Amdt. Dated: April 11, 2007

Reply to Office Action of 01/11/2007

REMARKS / ARGUMENTS

the Examiner's referenced "U-shaped channel", a portion of FIG. 2 is reproduced in relevant part

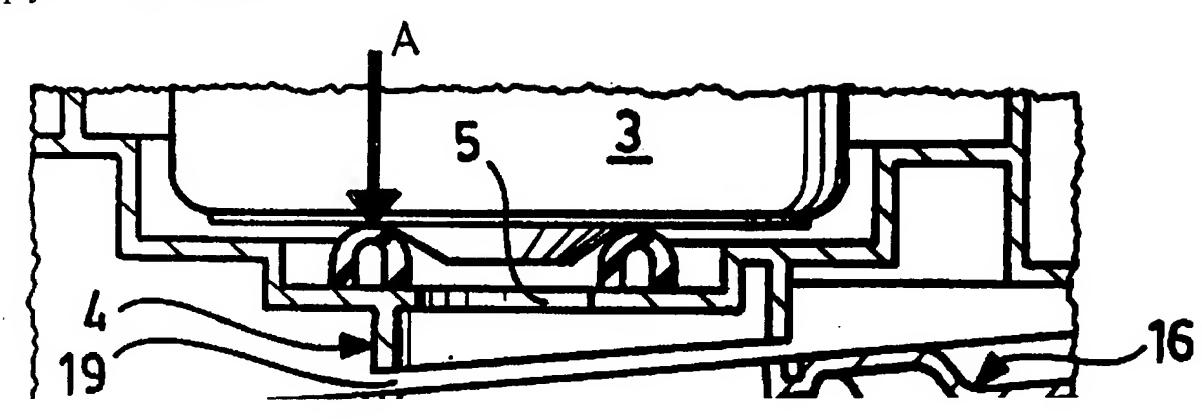
In making his argument, the Examiner contends that, in viewing figures 2 and 3 of

Schoenewald, there is an "elastomeric U-shaped member located above the suction opening 5 formed in the bottom side of the "motor mount" to form a lip extending from the first member of the motor mount". However, the Examiner has mischaracterized Schoenewald and its teachings.

Schoenewald. Further, in make his rejection, the Examiner refers to an "elastomeric" U-shaped

member, which is not the same as or equivalent to the Applicants present disclosure. Applicant's

below for purpose of clarity, showing the structure (A) to which the Examiner refers in detail

with an arrow. As is evident by the hashing marks on the designated portion, this "member"

referred to by the Examiner is clearly a separate material from the rest of the connecting piece

(4). Further, as can be seen in this figure, the channel the Examiner is referring to is clearly not

formed in one side of the motor mount member to form a lip that protrudes from the opposite

side, as recited in Applicants present invention.
